**County of San Mateo
Department of Public Works
Utilities-Flood Control-Watershed Protection**

**Plan Review
2184 and 2185 Cobblehill Place, San Mateo**

Subject: Highland Estates – Street Improvements Plans, 2184 and 2185 Cobblehill Place,
San Mateo County
BKF Response to County Sanitation District Review Comments

HIGHLAND ESTATES - STREET IMPROVEMENT PLANS
TICONDEROGA DRIVE, COBBLEHILL PLACE & COMPENS WAY
PLAN & PROFILE - COBBLEHILL PLACE
SAN MATEO COUNTY CALIFORNIA
CITY OF SAN MATEO

Sheet Number:
C3.10
OF

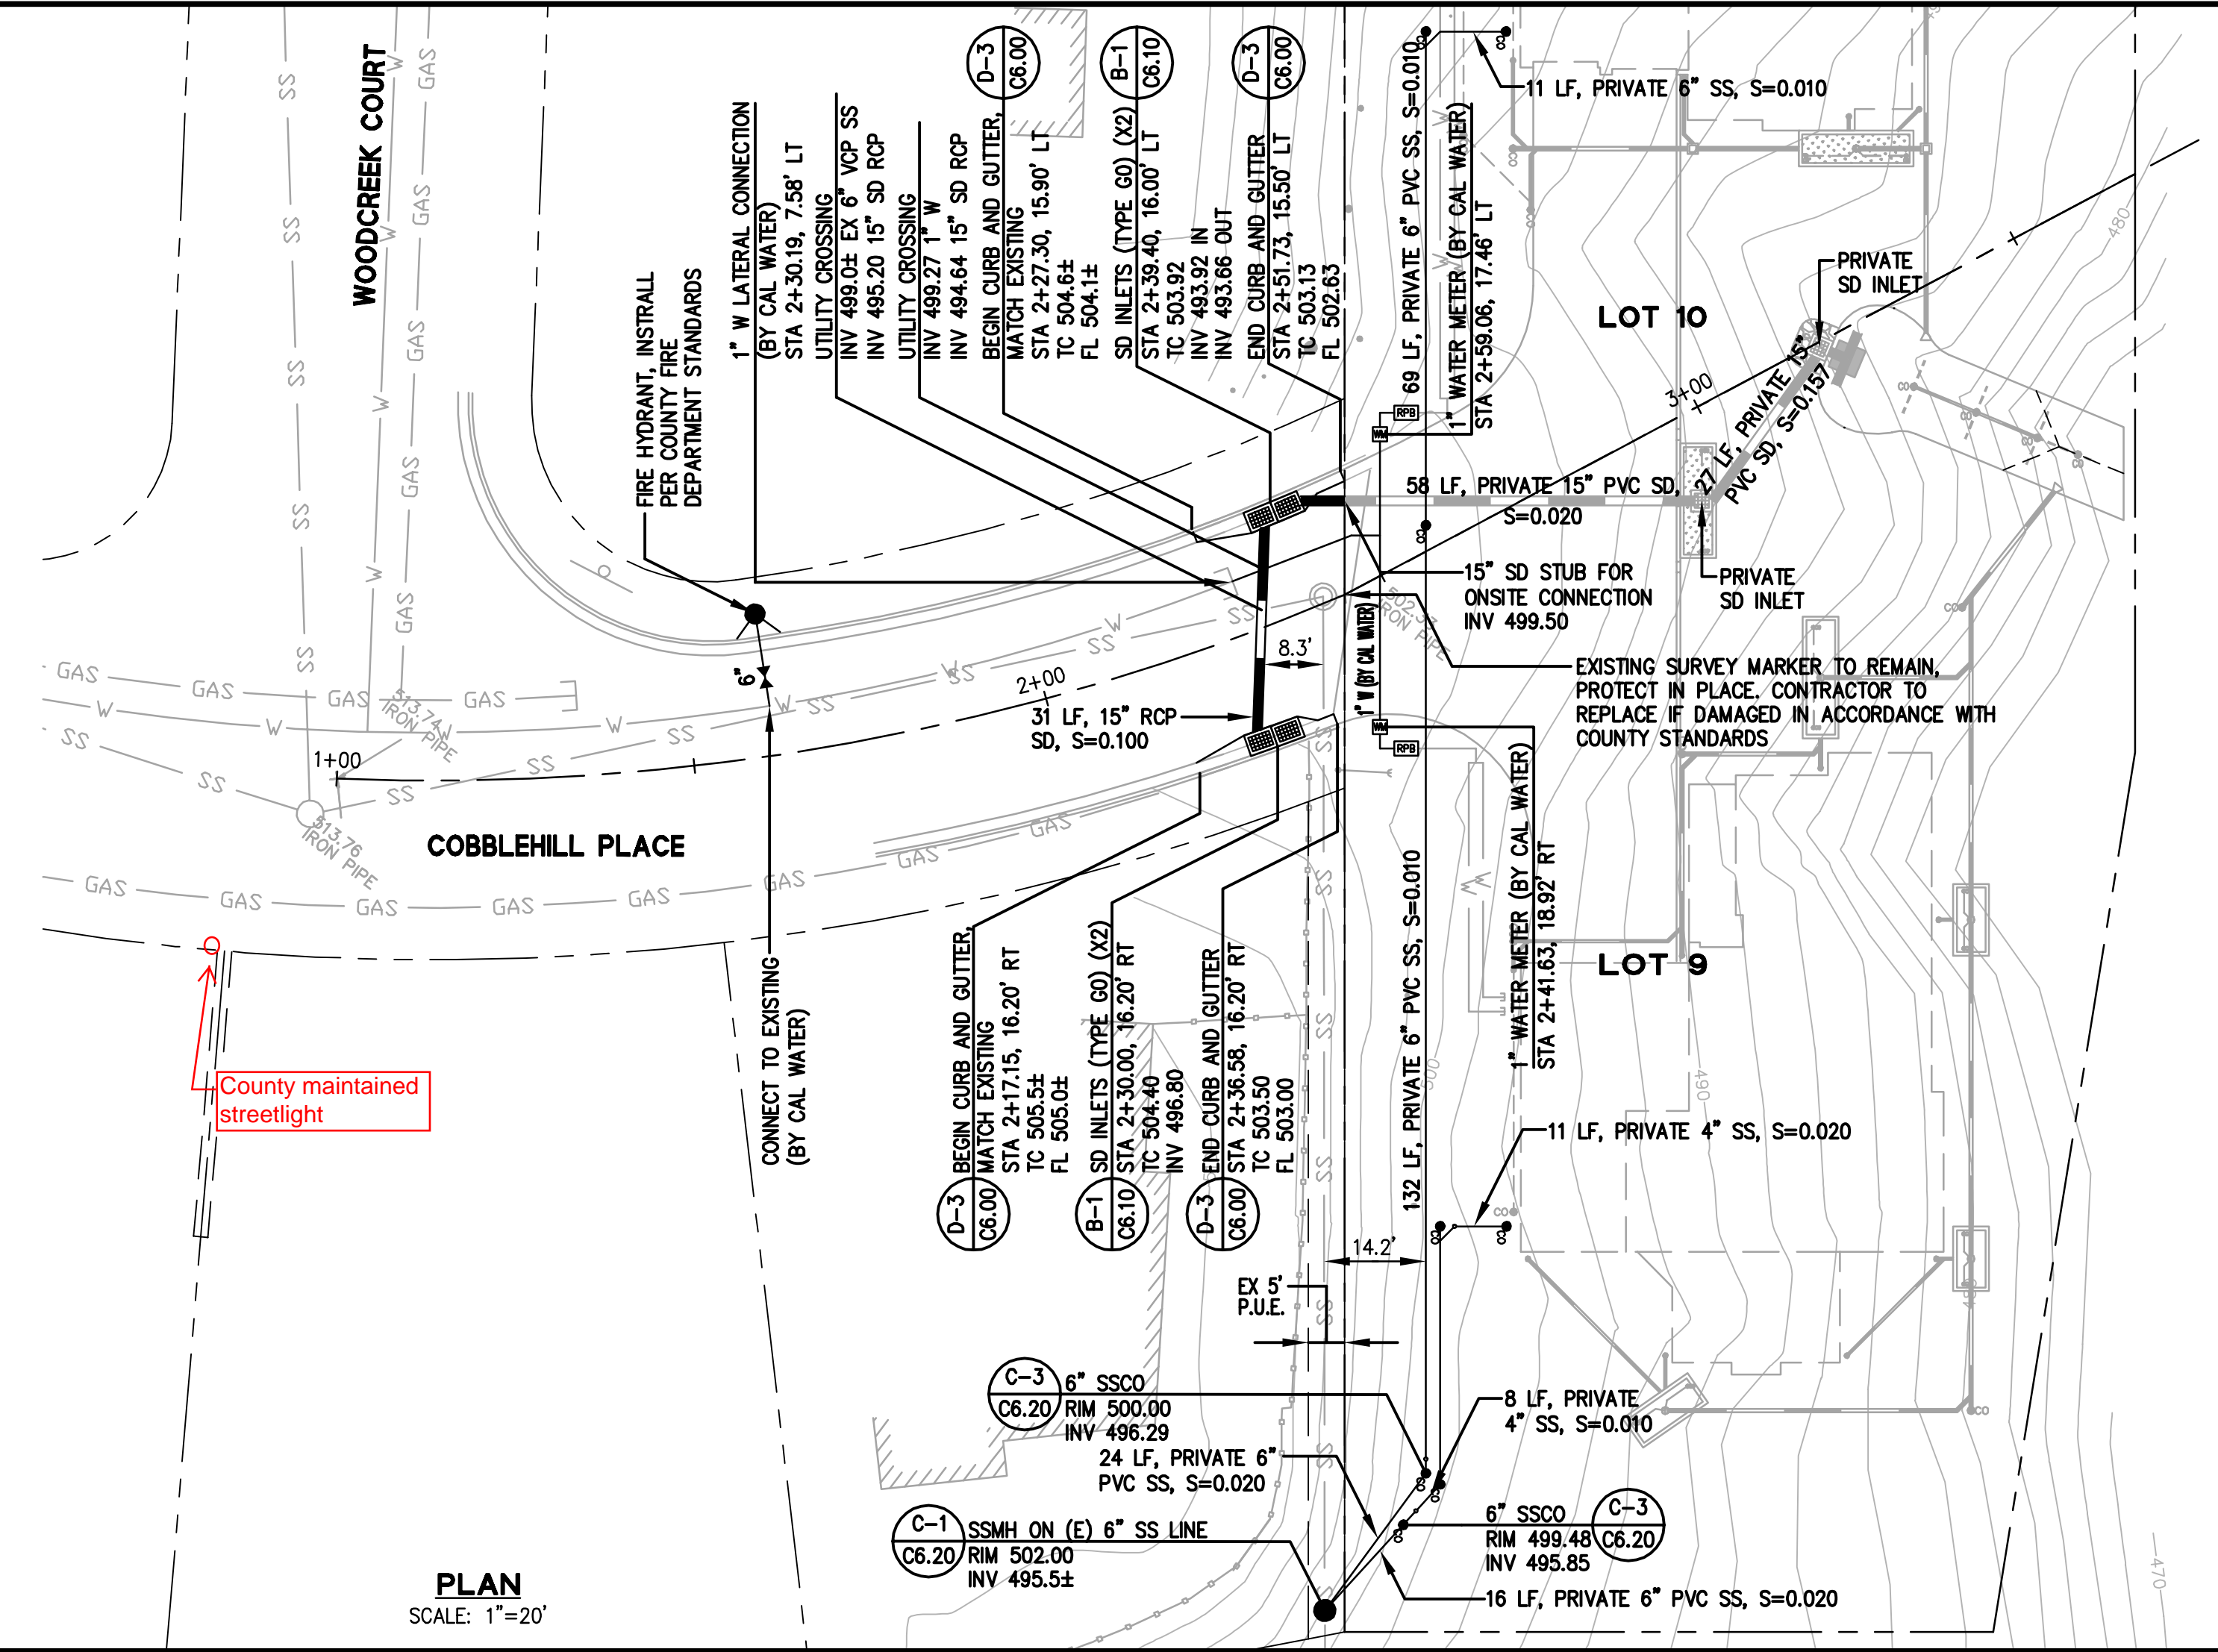
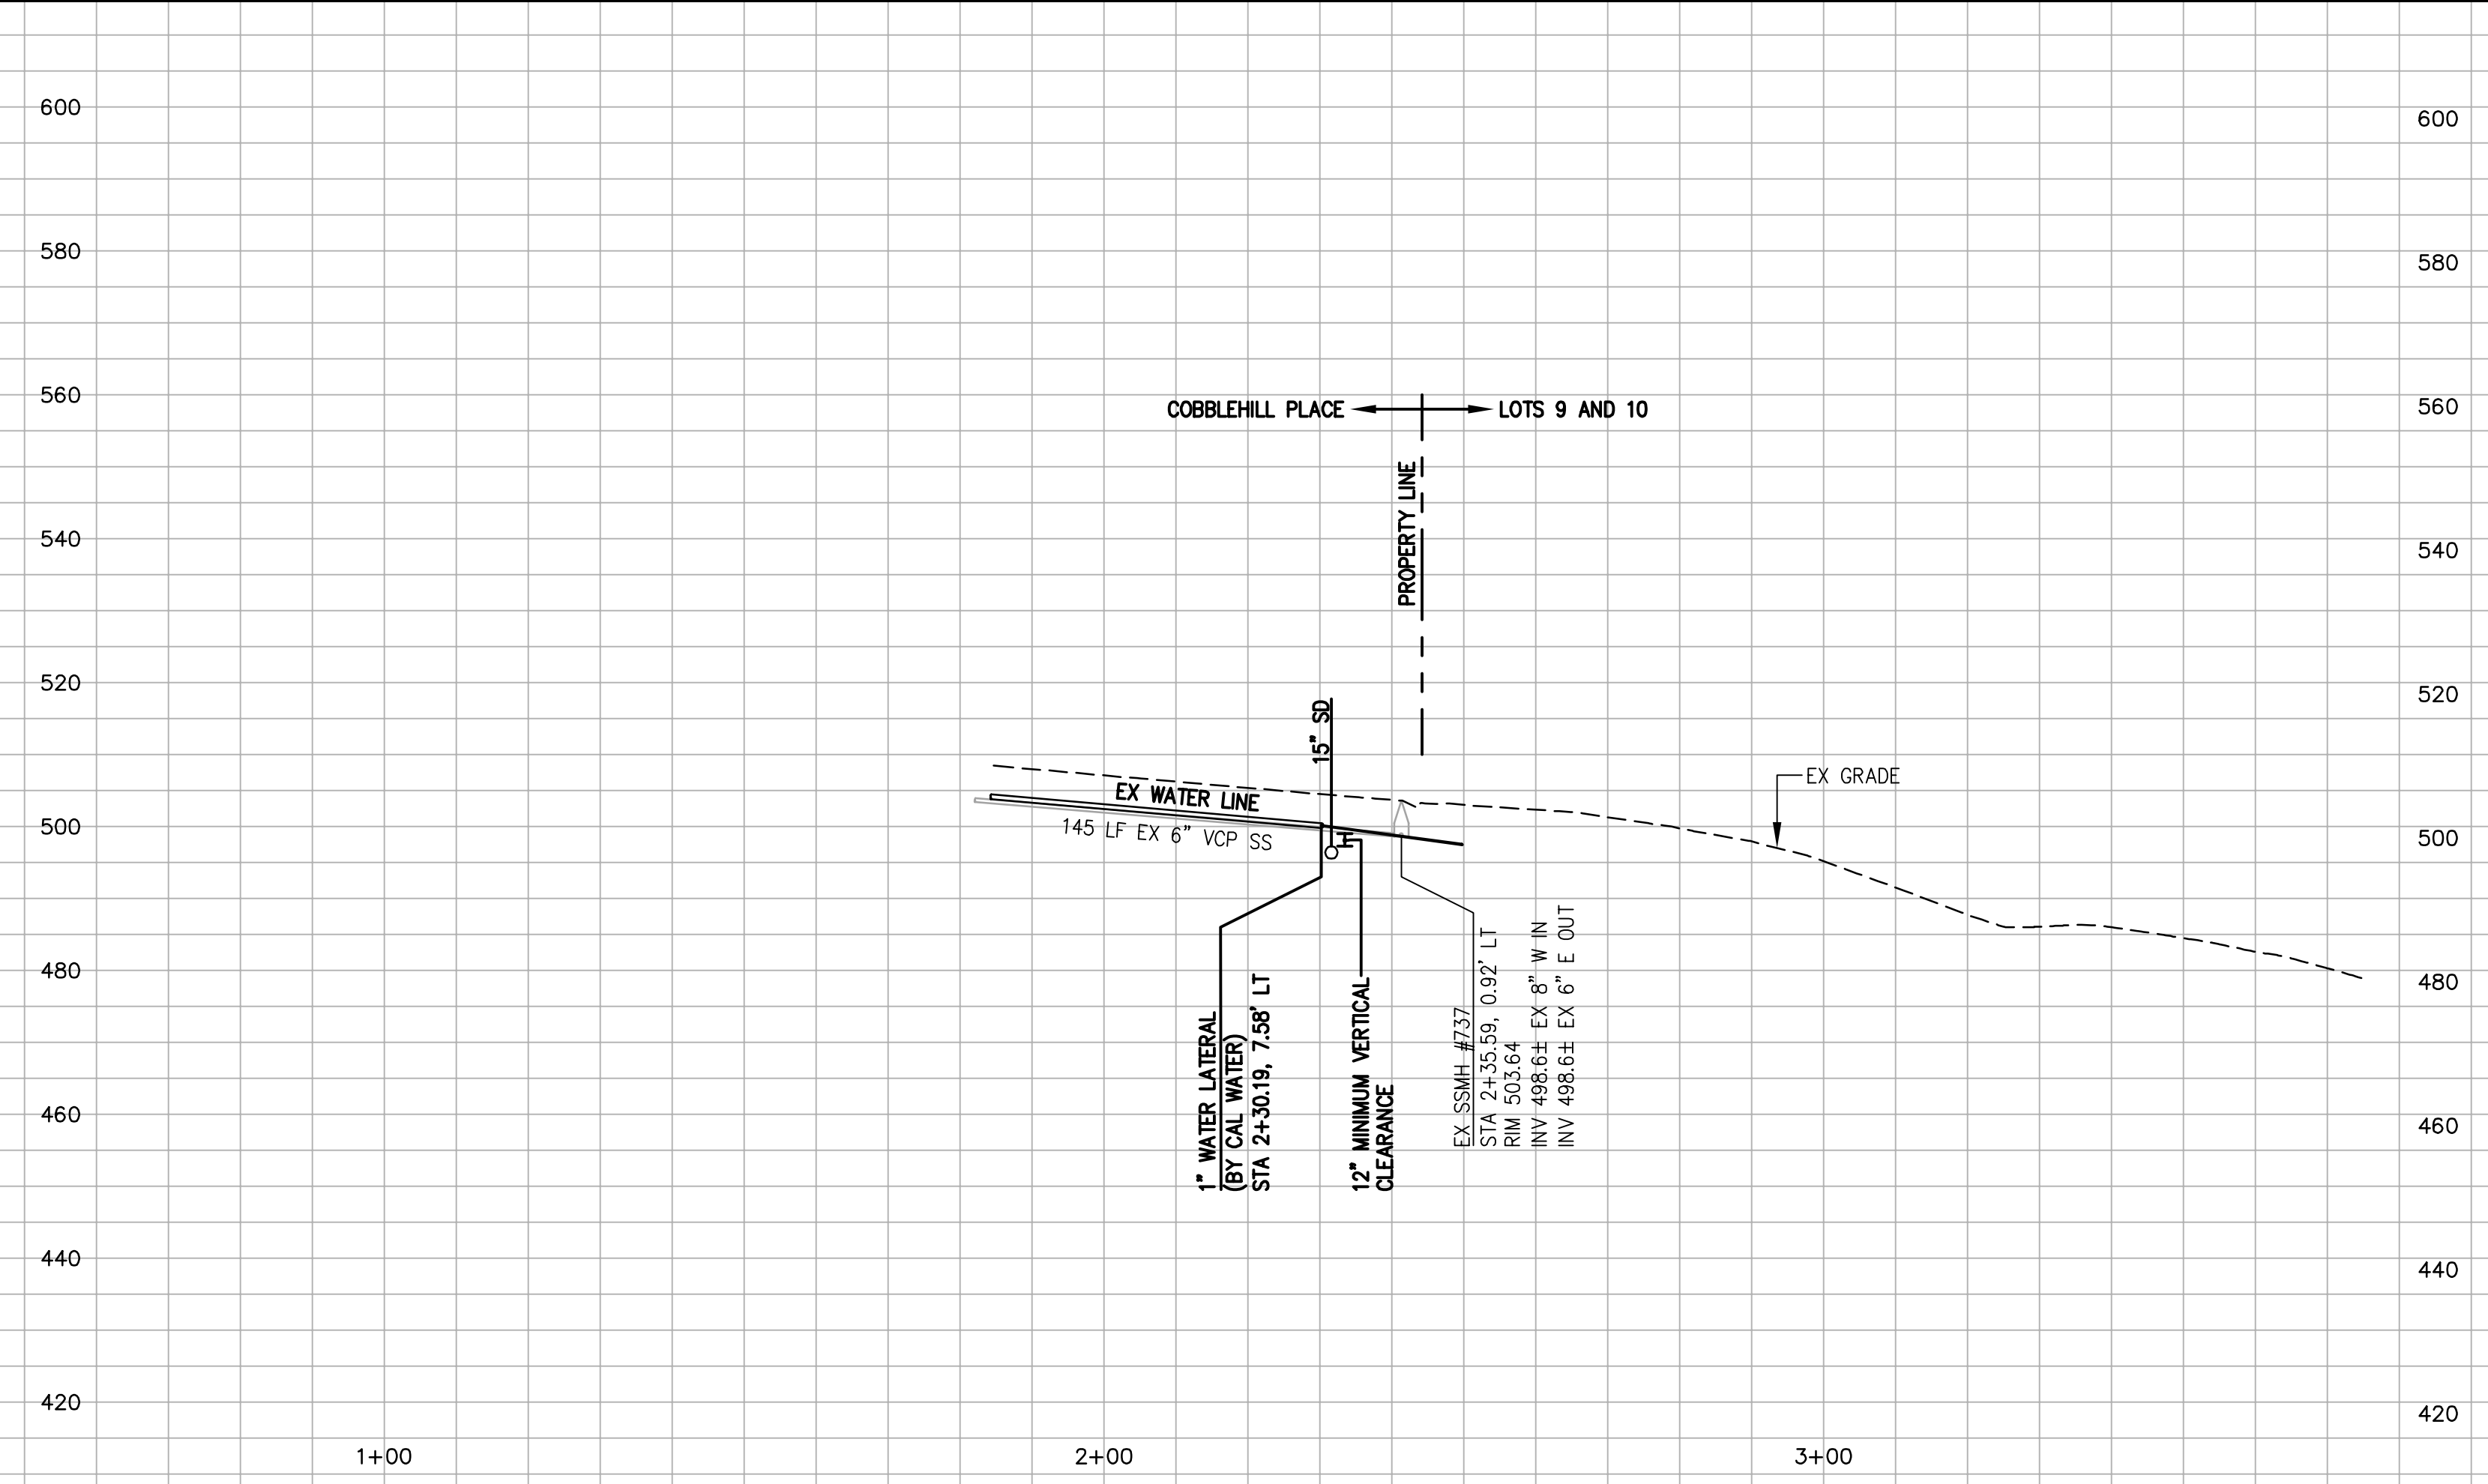
1. *Any crossings in the vicinity of an existing sewer manhole shall have a minimum clearance distance of 5' radius from the center of the manhole cover. The storm drain line shall be re-aligned to meet this requirement*

2. *All sewer main and lateral crossings must be located and potholed prior to storm drain installation to determine the exact depth. This note shall be added to the plans.*

3. *The proposed storm drain shall not be installed directly above and within the Sewer District main trench limits. This note shall be added to the plans.*

4. *Care must be taken to protect the existing Sewer District facilities during construction. Any damages to the Sewer District facilities during the installation of the storm drain shall be repaired by the applicant per the Sewer District's standard details and at the applicant's expense. The Sewer District must be notified of any damages to the sanitary sewer facilities and any repairs must be inspected by a Sewer District representative. Sewer District standard details can be found on our website at <http://publicworks.smcgov.org/sewer-services>. This note shall be added to the plans.*

5. *The proposed storm line appears to be parallel to the Sewer District Main. The horizontal distance between these utility lines shall be labeled on each sheet and where distance changes. If the horizontal clearance from edge of pipe to edge of pipe is 5' or less or if the proposed storm drain crosses the Sewer District mains, the following closed circuit television inspection requirement is required:*

- a. *The applicant or contractor shall perform closed circuit television (CCTV) inspection of the sanitary sewer mains within the project vicinity before and after construction to verify that no damages have occurred to the sewer facilities during construction of the storm drain. The video inspection shall be performed in accordance with the requirements described in the Special Provisions for Closed Circuit Television Inspection of Sanitary Sewer Mains (a copy can be obtained from our website at <http://publicworks.smcgov.org/sewer-services>) and labeled with the Sewer District manhole numbers. The CCTV inspection videos shall be submitted to the Sewer District for review. Any damages to the Sewer District facilities caused by the installation of the storm drain that are revealed in the CCTV inspection shall be repaired by the applicant per the Sewer District's standard details and at the applicant's expense. The Sewer District must be notified of the schedule of CCTV work prior to commencing. A note indicating these requirements shall be added to the project plans.*

Storm drain line has been realigned to maintain a minimum of 5' horizontal clearance to the existing sewer manhole. See sheet C3.10.

Note has been added to plans. See sheet C3.10.

Note has been added to plans. See sheet C3.10.

Note has been added to plans. See sheet C3.10.

Notes have been added to plans. See sheet C3.10.
